July 12, 1967

KINGSTON STEAM PLANT - ASH DIKES

On July 3, 1967, J. P. Hillier Stivers and Robert J. Bowman met with Meigs Brewer, Jr., and Shelton Johnson of Power Production and Buford Cross, Assistant Superintendent, and Buford Street, Mechanical Supervisor, of the Kingston Steam Plant at Kingston Steam Plant for an inspection of the ash dikes.

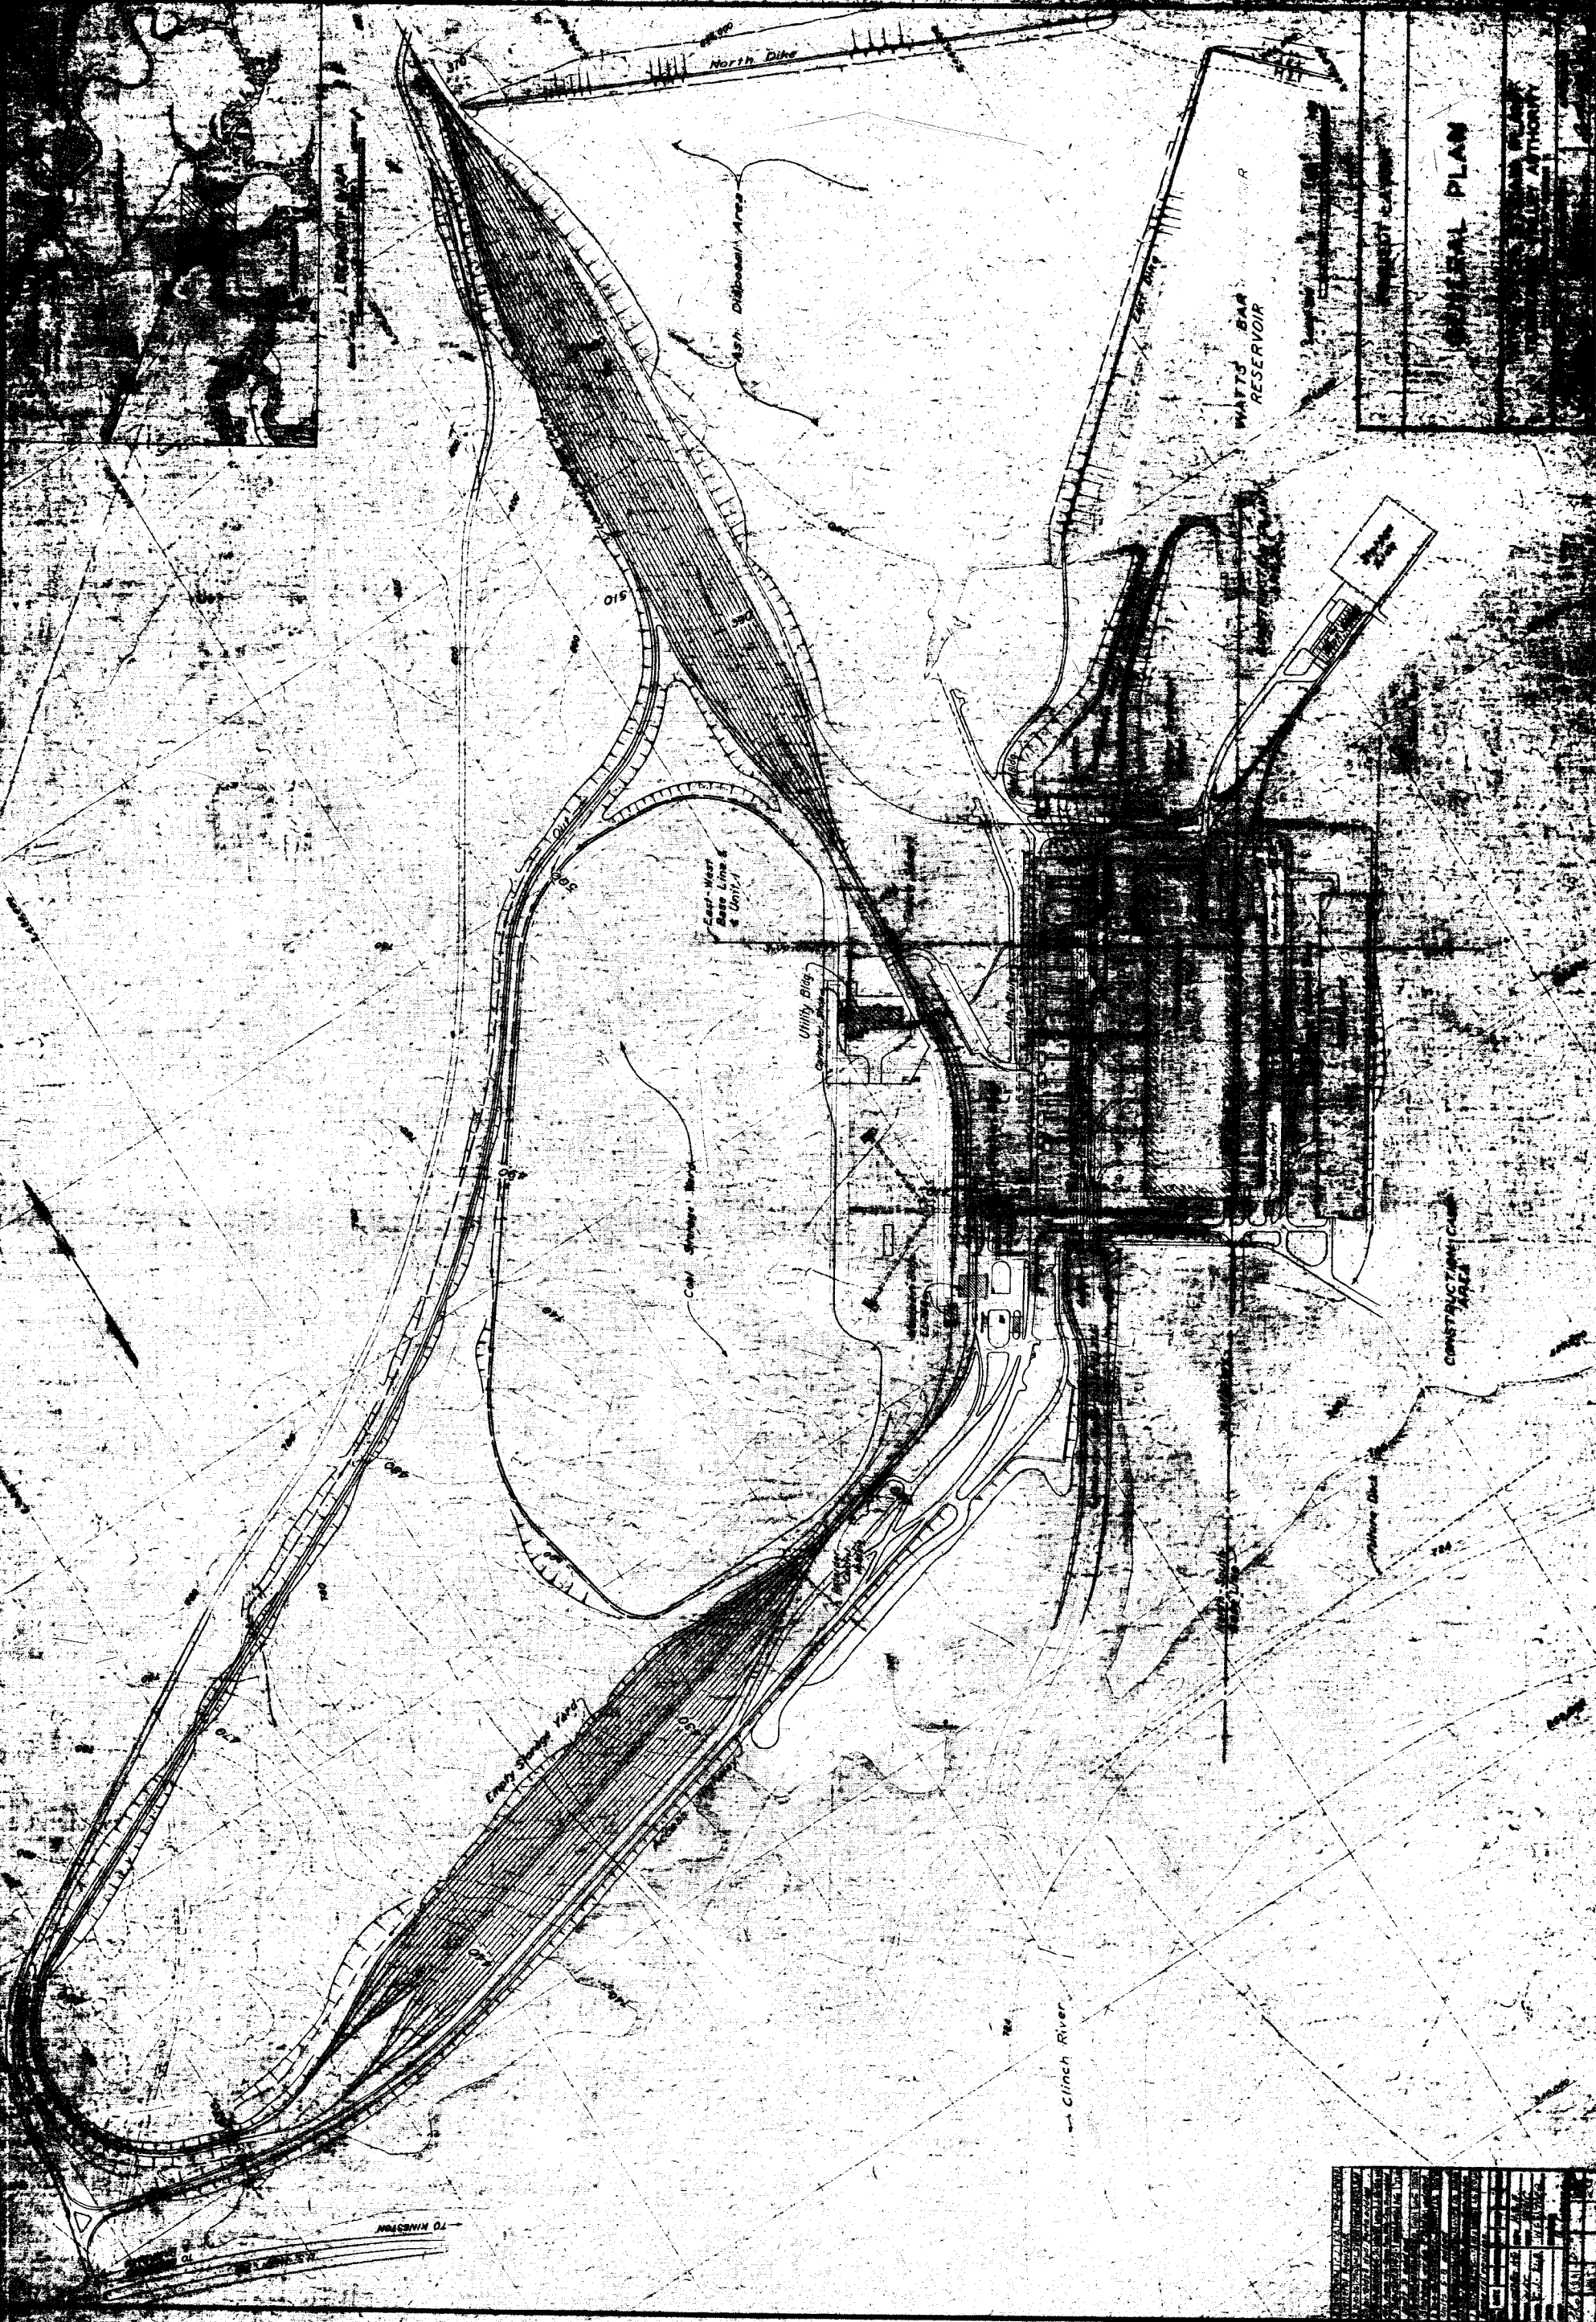
On July 3, 1967, there was approximately an area of two acres of floating ash from 1-1/2 to 2 inches thick. The location varies with the wind, but usually is diametrically opposite the spillways. A square wooden skimmer floating on metal drums (see photo) is used here instead of the circular metal type we have designed. We see no objection to the wood type except this one does not extend far enough below and above the water level to hold back floating ash.

Pictures showing Spillway inside Reservoir
Structure is too short to extend far enough into
water to skim off all ash and to prevent
from going over. 7-3-67

NO. 104
DATE: 6-9-51
SHEET: 5
OF: 4
JOB NO.: 10N400 R4

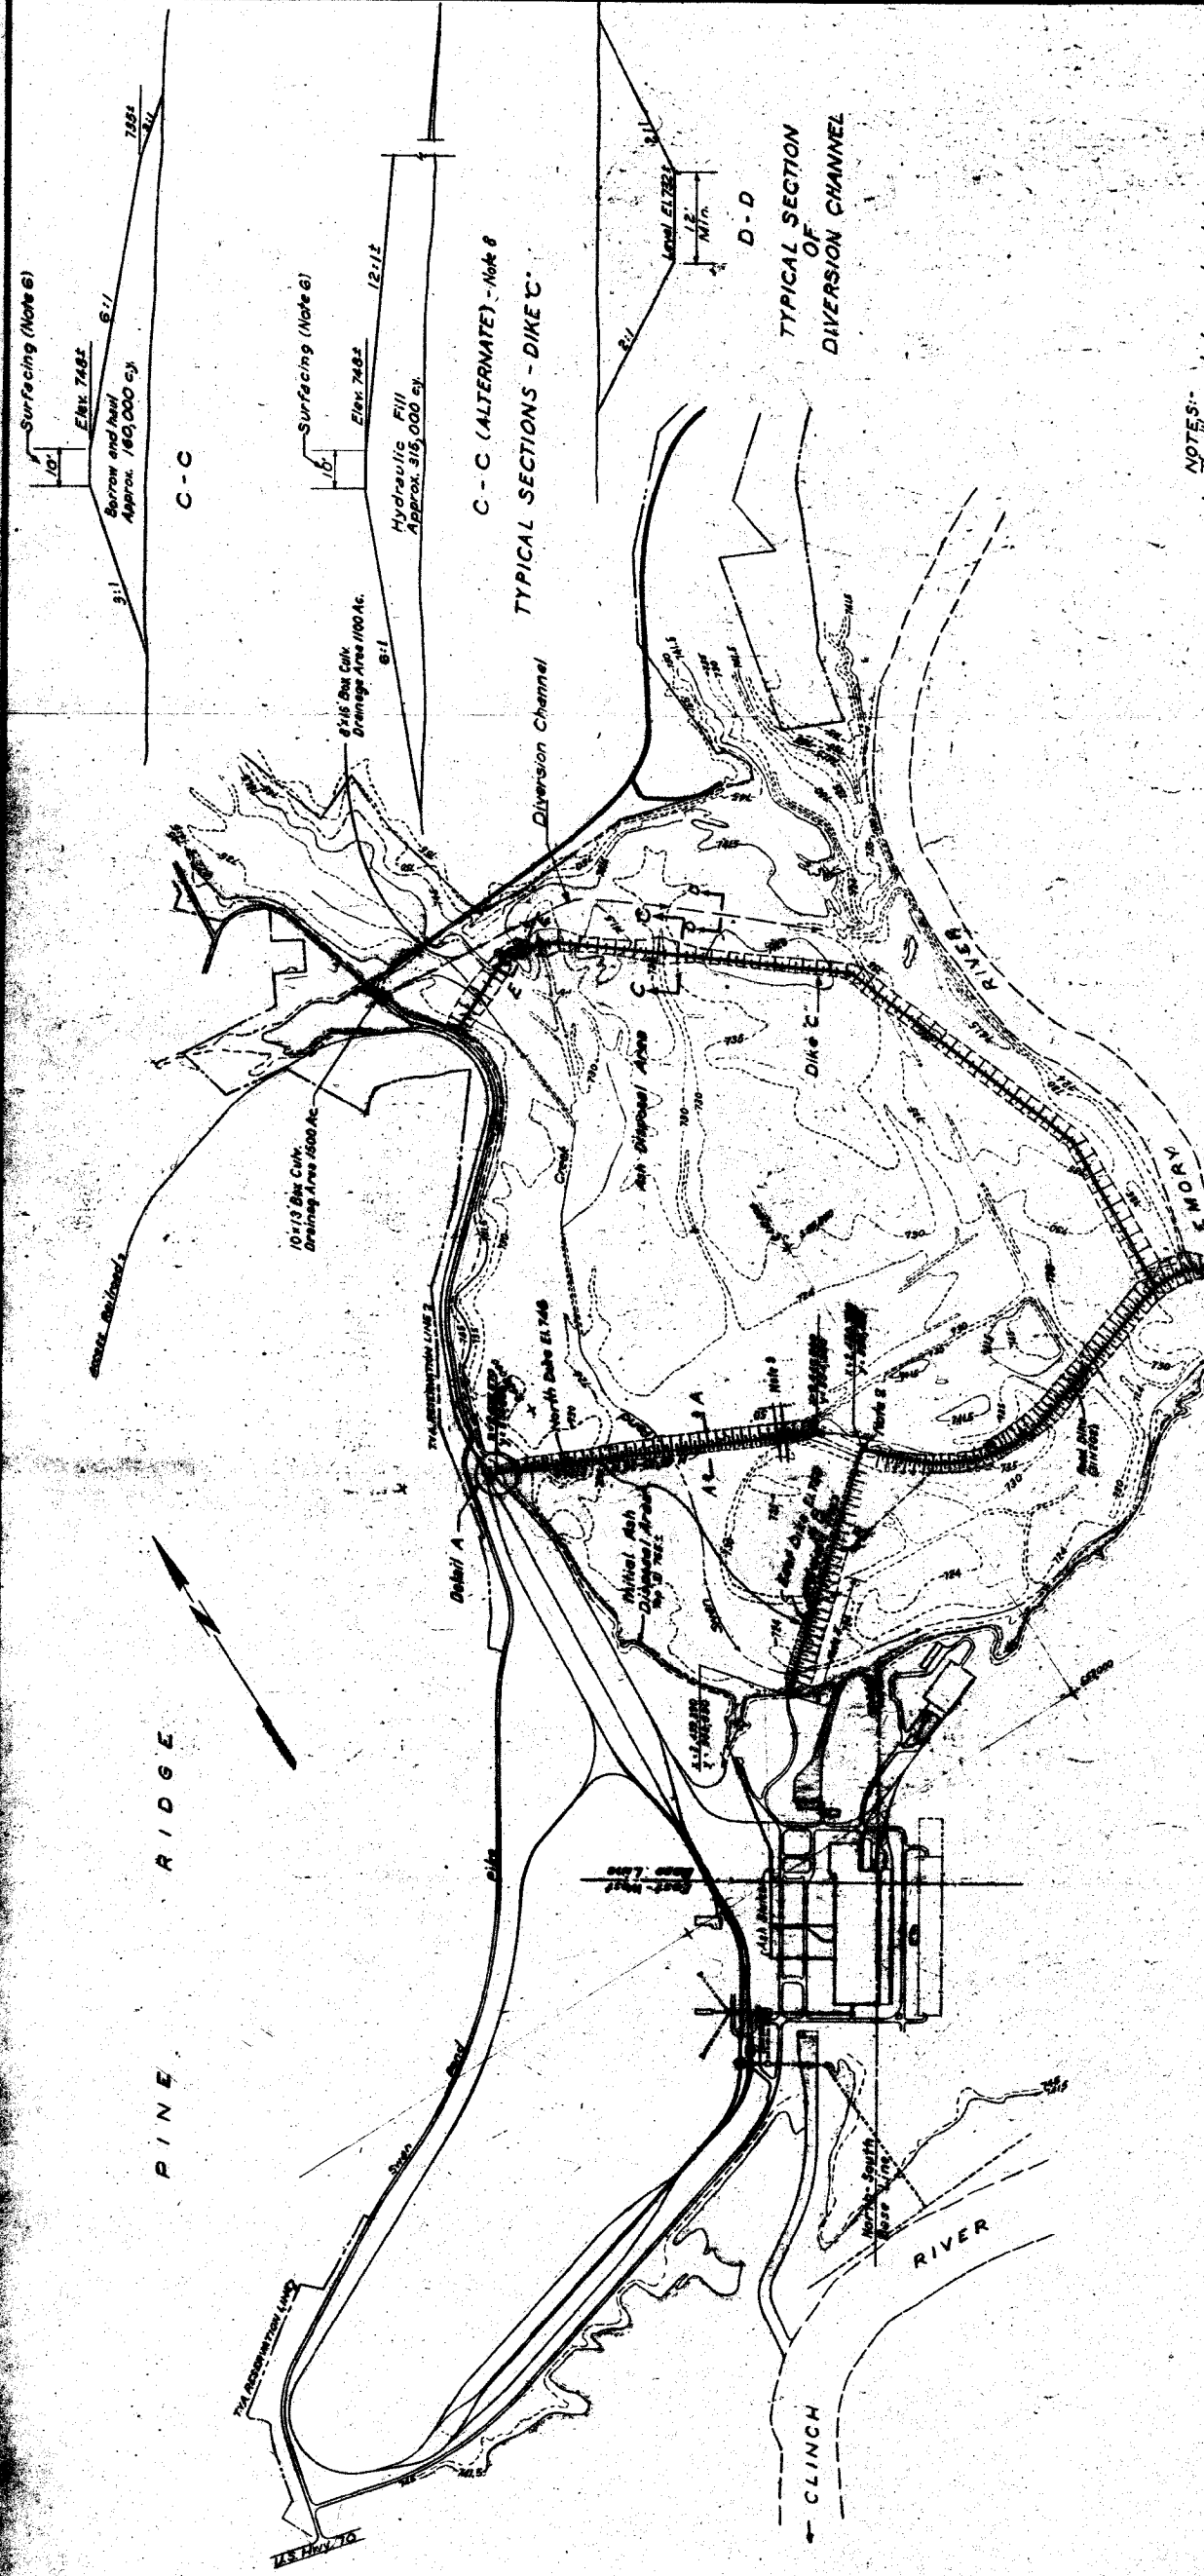
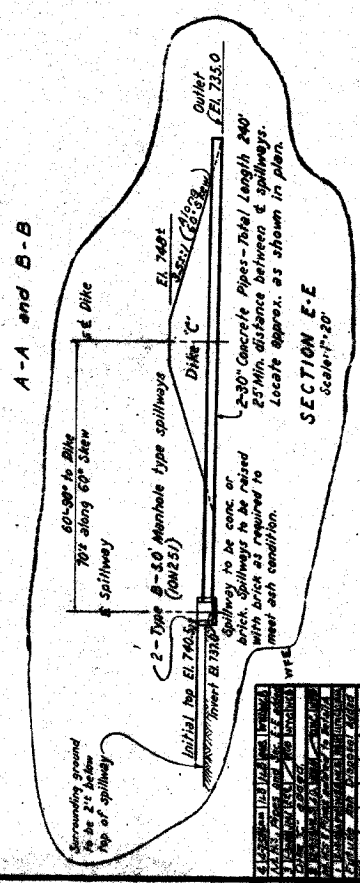
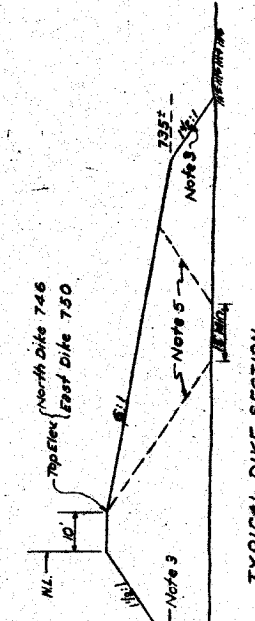
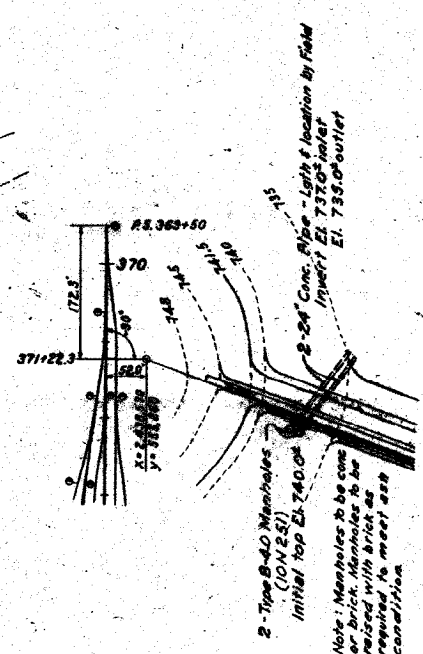
At the time of our visit the people at the plant were talking about a 3-foot increase in the elevation of the water on the inside of the dike. This would require raising of the dike to prevent the 4- to 6-foot waves that have been observed from overtopping the dike. Even a 2-foot increase in water elevation without raising the dike would reduce the freeboard below a safe minimum. The reason for raising the water level was understood to be to provide more dilution. Unless additional depth is proved to be required, the depth of water on the inside should be kept about as it now is, in order to minimize wave action and head against the dikes.

Both pipe spillways are flowing full at the top with water only a few inches above the lip and seem to have no difficulty in taking care of the water that is discharged into the pond. Consideration should be given to installing an additional spillway to allow crossdiking to reduce the inside wave heights. At the present time the ash at the end of the sluice pipes is being worked by mechanical equipment. The recommendation was made that an immediate start be made on raising the dikes. We will make a revision on the 10N400 drawing giving specifications for raising the dikes.

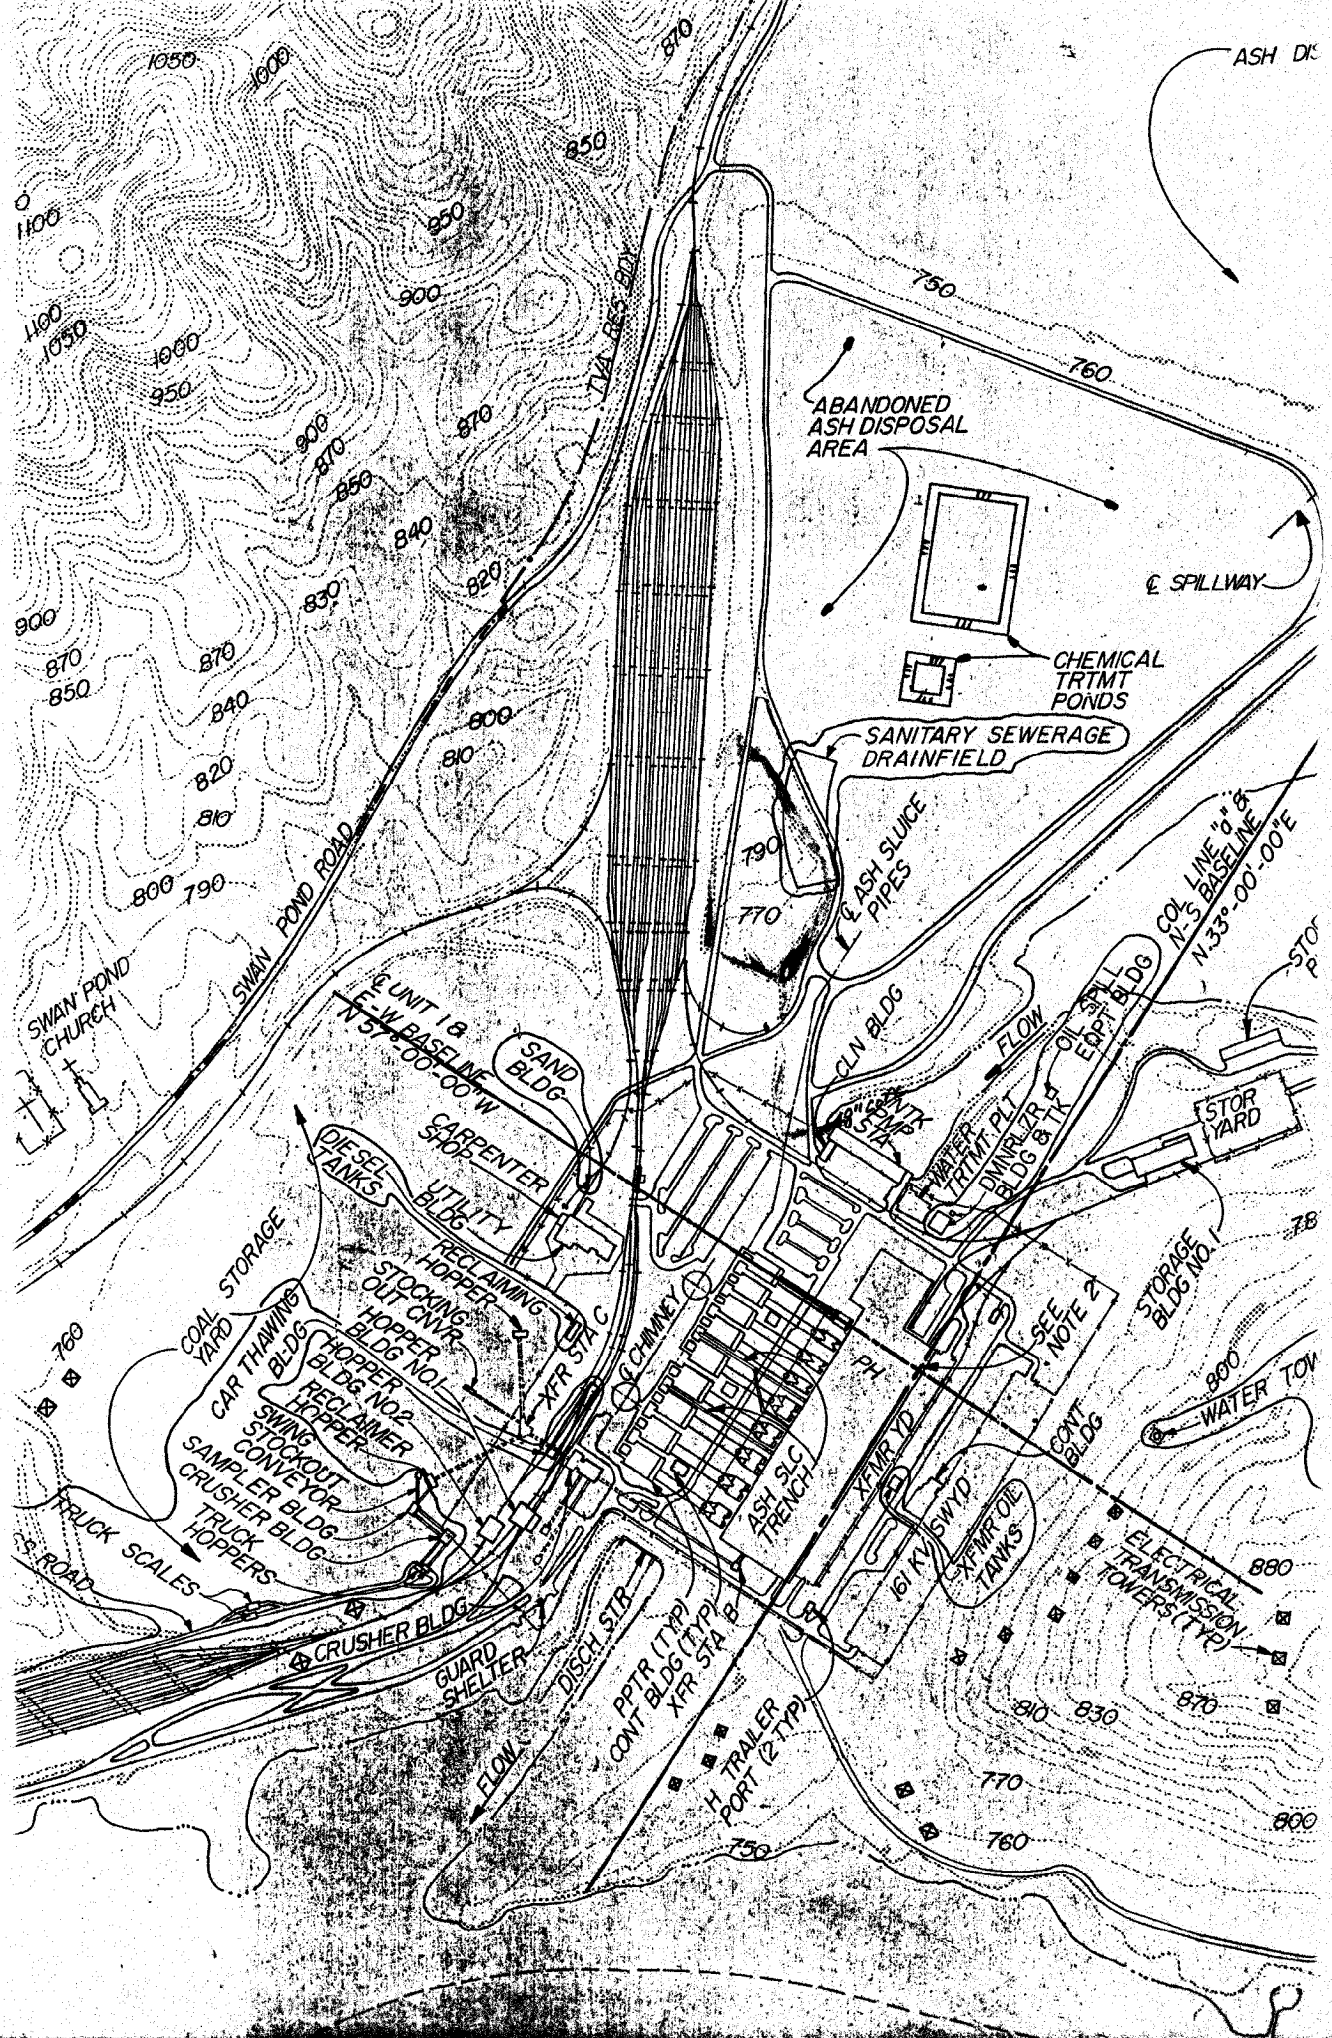
*Flat slopes inside and outside of dike
7-3-67*

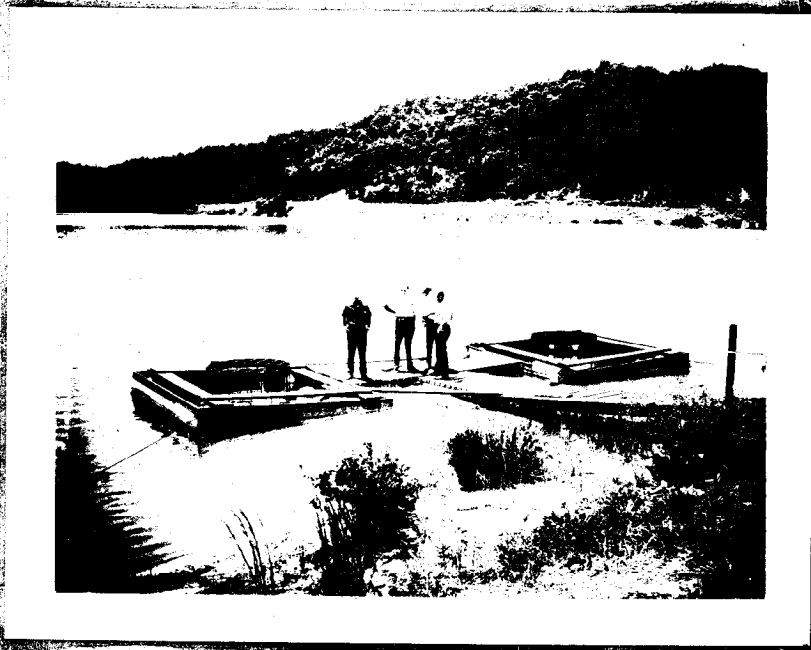
*Wave action inside dike cuts back into fill,
7-3-67*
